City of Alexandria, Virginia

MEMORANDUM

SUBJECT: 2ND CONCEPT REVIEW OF 899 AND 999 NORTH HENRY STREET
BAR CASE # 2022-00175

Figure 5: Massing study showing shoulders along east side of building

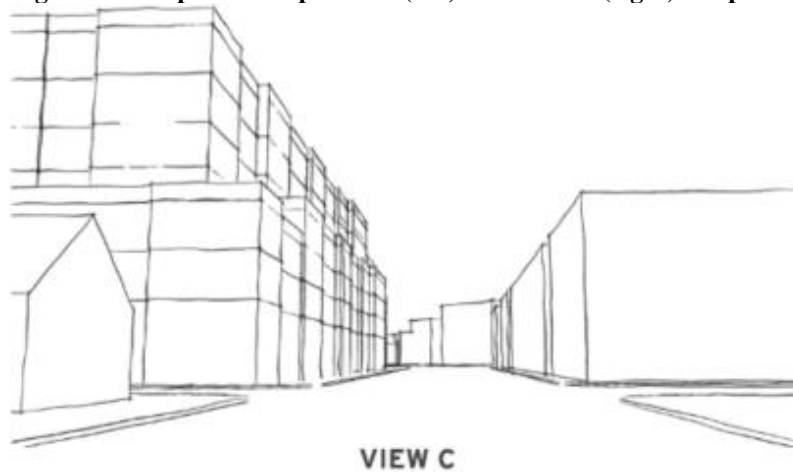
Both the Board and staff noted that the previous submission included building shoulders at the west and south sides as shown in the small area plan but did not include them on the east side facing the smaller James Bland multi-family buildings and the historic district. The revisions to the design since the last submission are primarily related to the organization of the site and the ground floor functions, however the applicant has submitted revised massing studies that show new shoulders along the east side of the buildings (Figure 5). The design of these shoulders will be further developed as the project progresses but as shown in the massing studies, this change helps to transition the building from the lower scale buildings to the east of the site to the taller buildings to the west.

The revised massing diagrams include setbacks at the east side of the building similar to those previously shown along the west side. This is in direct response to comments from the Board and staff and help to make the building compatible with the neighboring structures. Staff recommends that as the design progresses into a discussion of the architectural character, the different portions of the building are considered in relation to their surrounding context and that the massing be organized into complete three dimensional building components with a definable building parti.

Figure 4: Comparison of previous (left) and revised (right) site plans

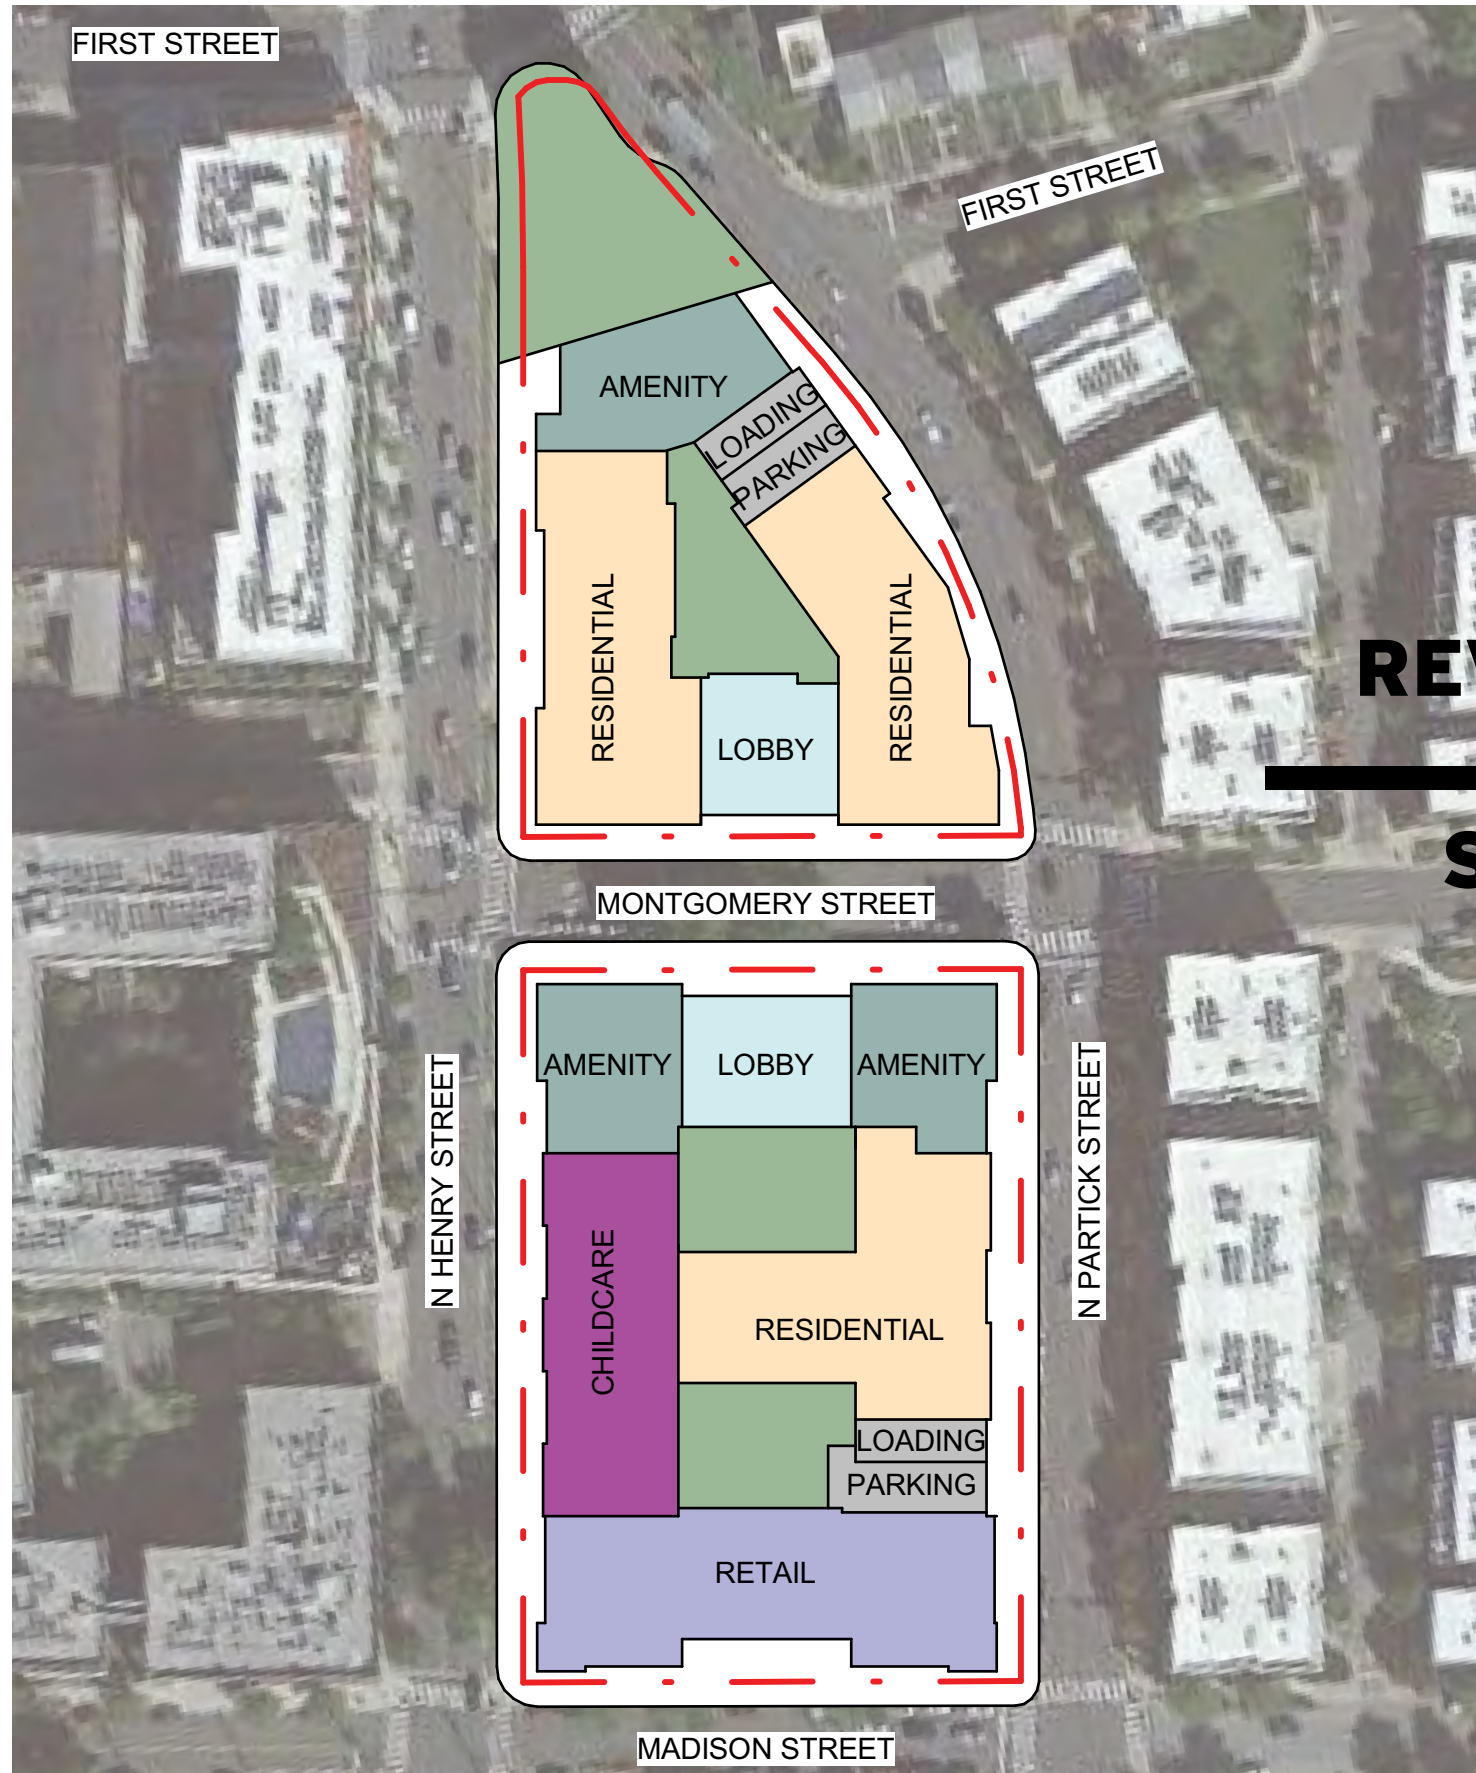
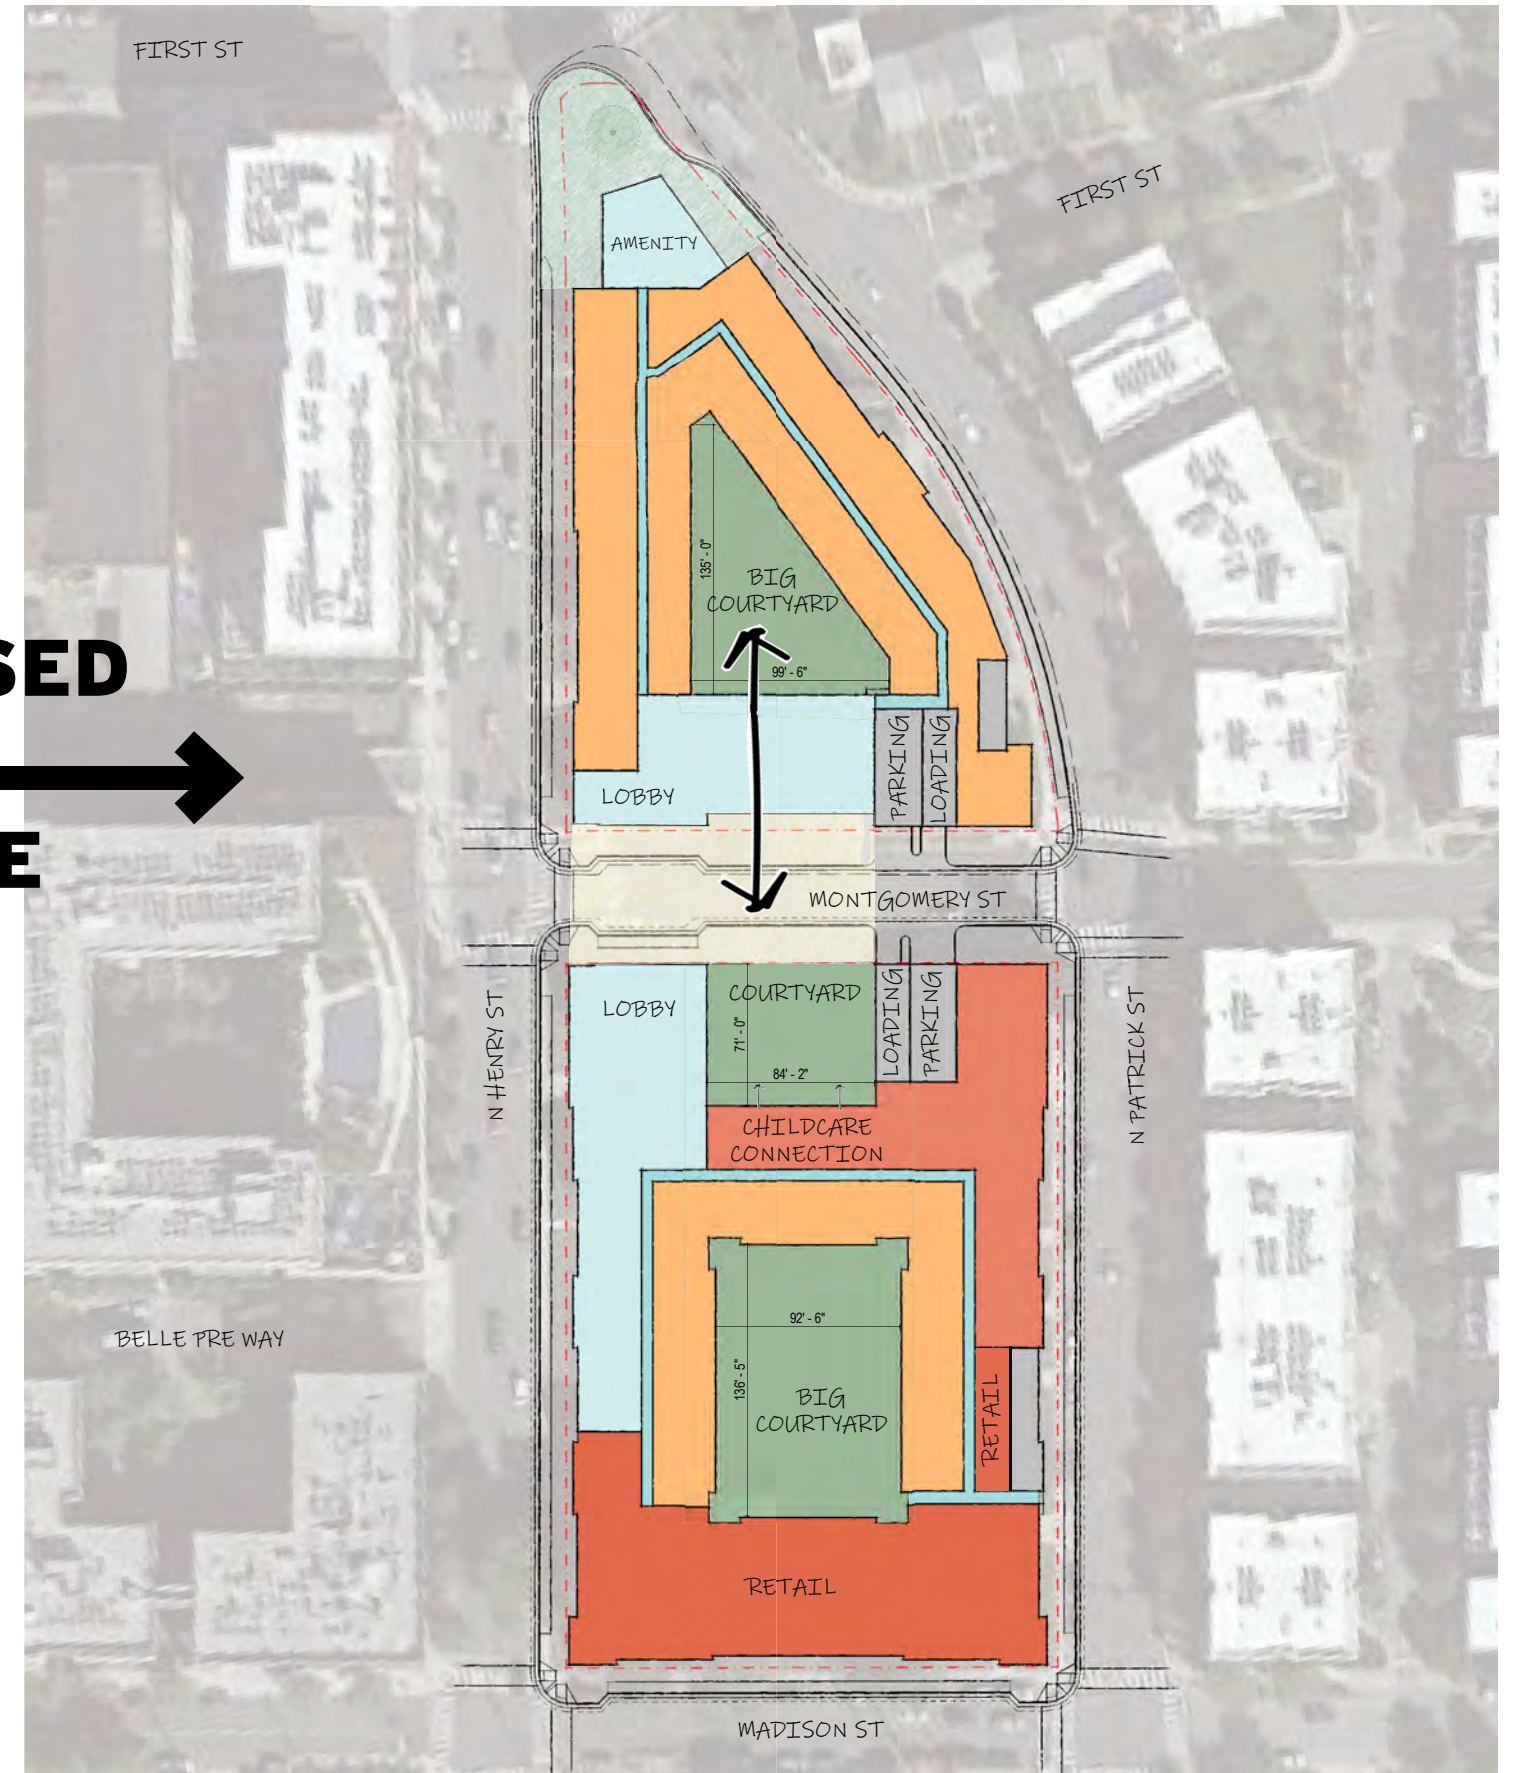
In response to Board comments regarding the configuration of the massing of the north end of the north building and the proposed adjacent park, the applicant has significantly revised the site plan. In the revised design, the north end of the building has been pushed north into a portion of the previously proposed park. A signature amenity space is now being located in this area of the building that will interact with the exterior open space. It is important to note that per City Master Plan requirements, the project must maintain an open space in this area of the site. The revised design maintains the required open space while being responsive to the Board's comments regarding a preference for locating ground floor open space elsewhere on the site. Pushing the building into this area of the site also serves to create a unique form in response to the Board's request that this portion of the building become an iconic gateway into the historic district. The relocation of the building massing north on the site also allows the applicant to respond to concerns from the Board regarding the limited size of the previously proposed interior courtyard. In the revised design, the internal courtyard has become significantly larger.

A theme consistent throughout many of the Board's comments was a desire for the applicant to reconfigure the building and the site layout to allow for more transparency and ground floor open space that is towards the outside of the building rather than being contained within small interior courtyards. In response to these comments, the applicant is proposing a reconfiguration of the building that will create a connection between the north and south buildings through a series of spaces linking across Montgomery Street. As mentioned above, the internal courtyard on the north building has gotten larger and has pushed further south. The applicant is also reconfiguring the lobby of the north building to extend to the North Henry Street corner and is proposing that this lobby include a level of transparency between Montgomery Street and the internal courtyard, allowing for a connection between the courtyard and the sidewalk.

On the south building, the two internal courtyards have now been replaced with an open courtyard on the north side of the building that is directly opposite the lobby of the north building and a larger internal courtyard further south in the building. The lobby in the south building has been relocated so that the main entrance is at the northwest corner of the building, opposite the main entrance to the north building, and stretching along the west elevation. The inclusion of the open courtyard at the north end of the building dramatically changes the massing of the building and provides some of the exterior ground floor open space requested by the Board. The applicant is locating the childcare area directly adjacent to this open courtyard. This area can be used as a play space similar to the exterior spaces in the existing condition.

The creation of an open courtyard at the north side of the south building along with the reconfiguration of the lobbies and amenity spaces creates a strong connection between the two buildings while also allowing for architectural variation. The new open courtyard addresses comments from the Board regarding recreating the open streetscape of the current design. This reconfiguration also allows for the creation of a larger internal courtyard instead of the two small courtyards previously shown.
